HARTING Pushing Performance	HARTING Product Change Notification	PCN
--	--	------------

PI00000199-US

Product Range: Han-Modular®

Title: PCN Han M12 Crimp Metal Nut

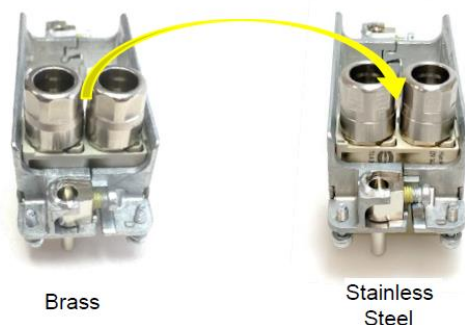
The outer diameter and material of the cable gland metal nut will be modified.

- Reduction of the nut outer diameter from 14.5 to 14.0 mm.
- Change of the material from brass, nickel plated to stainless steel without plating.

This improvement enables isolation between the two M12 connector shieldings such that there is no electrical contact. The gap between the nuts will be increased by 0.5 mm from 0.3 to 0.8 mm.
